Public Meeting
Town of Rockport, Maine
Planning Board Agenda
Thursday, November 21, 2019
5:30 p.m. @ Rockport Opera House
6 Central Street, Rockport Maine

RE: Site Plan Review Application
Rockport Harbor Hotel
20 Central Street
Rockport, ME

TO: Planning Board, Town of Rockport, ME
CC: Bill Najpauer, Planner and Community Development Director, Town of Rockport
FROM: Nate McLaughlin, P.E., Woodard & Curran
DATE: November 20, 2019
RE: 20 Central Street LLC - Rockport Hotel Development Plan Review

Subject: **20 Central Street LLC, Rockport Harbor Hotel** **Project #: 2018-128**
Response to Wood & Curran Sanitary Review

SITE PLAN

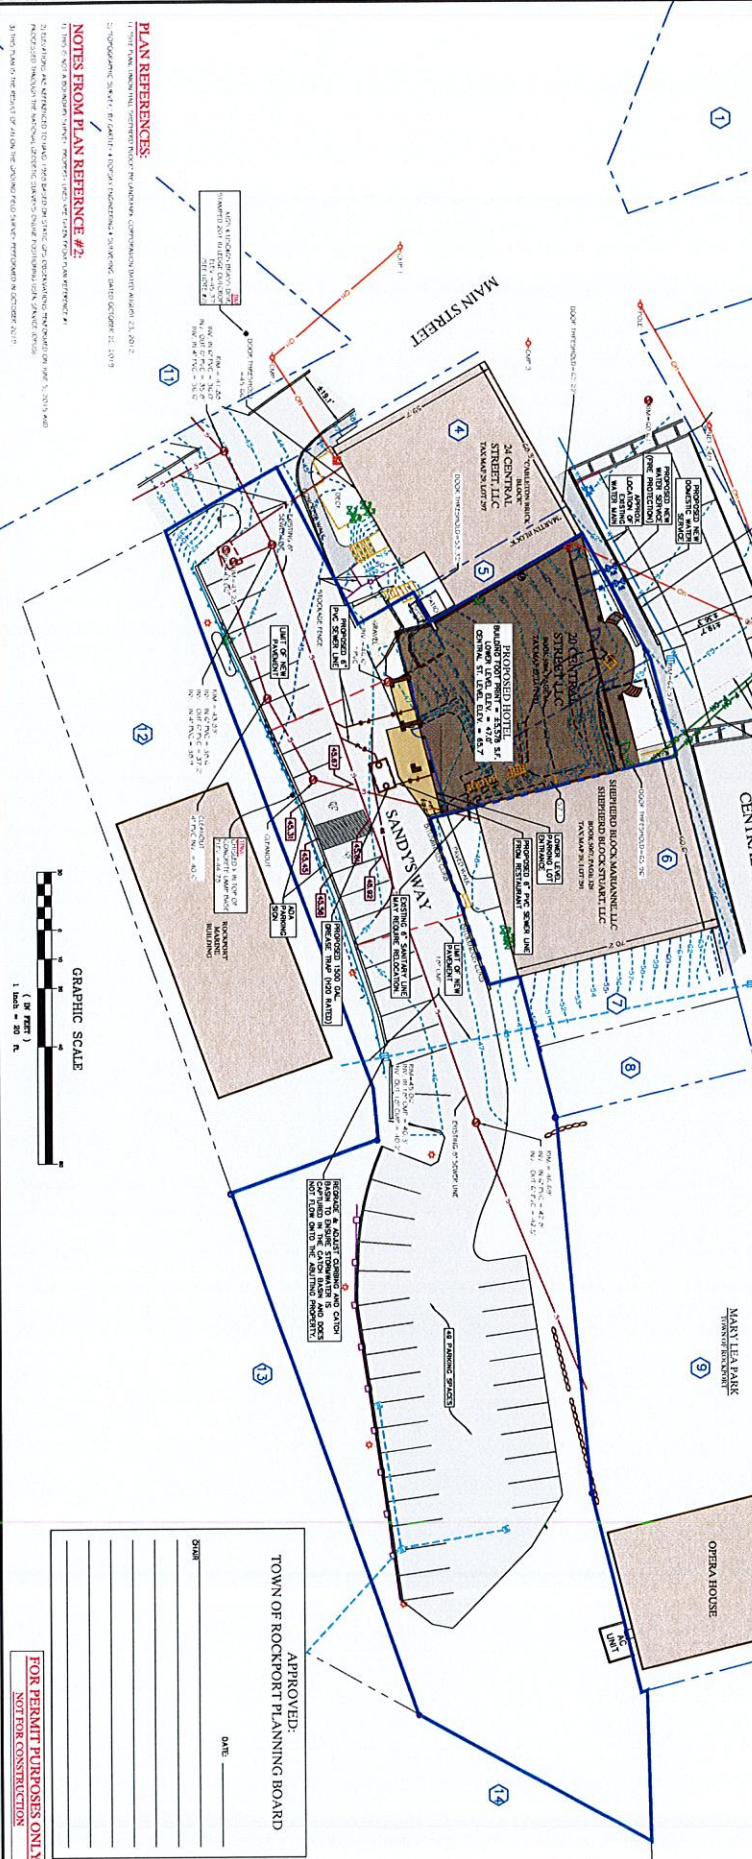
Attachment #1 to this memo is the most recent site plan that W&C has received and reviewed for the proposed development. W&C has reviewed the plan and presents the following comments for consideration by the Planning Board.

2. The manhole (MH) with rim elevation 41.88 in Main Street is noted to have a 6-inch pipe in from the parking lot to the left and a 6-inch outlet pipe that runs down Main Street towards the Main Street Extension PS. The original design drawings for this area of sewer indicate the outlet pipe is 8-inch and the pipe from the parking lot was intended to be 8-inch. W&C recommends additional investigation to confirm the pipe sizes listed on the plan.

3. The plan appears to indicate that the Rockport Opera House is tied into the sewer that runs through the private parking lot off Main Street. The original design drawings have the Opera

4. It is assumed that the proposed 1,500-gallon H2O-rated tank to be located in the private parking lot is a grease trap and will intercept the sewer lateral from the proposed restaurant. W&C recommends having the grease trap labeled as such on the development plan. It is also recommended to have the 4-inch lateral labeled as "restaurant lateral" if applicable. G&D may want to consider upsizing the 4-inch lateral from the restaurant to 6-inch to reduce the risk of grease accumulation in the pipe.

5. Not enough information has been provided to W&C on the proposed restaurant to determine if a 1,500-gallon grease trap is appropriate. W&C recommends the Planning Board inquire further on how the grease trap size was determined. Keeping grease out of the Town's sewers and pump stations is of the utmost importance.

6. A note calls for a new 6-inch PVC sewer line inside of the Shepard Building, although no sewer line is indicated. W&C recommends the Planning Board seek clarification if a new sewer line will be installed in the Shepard Building and where it will connect to existing sewer.

4. The latest site plan (attached) clearly labels the 1500 gallon, H2O rated grease trap. G&D is fine with upsizing the 4" lateral and from the restaurant to a 6" lateral, that revision is made on the attached C1 sheet.

5. The grease trap sizing calculations (attached) show a required size of 1020 gallons, the 1500 gallons is quite conservative.
6. The note referencing a new 6" PVC sewer line inside the Shepard Building was an errant note on a preliminary plan. There is no new sewer line proposed in the Shepard Building.
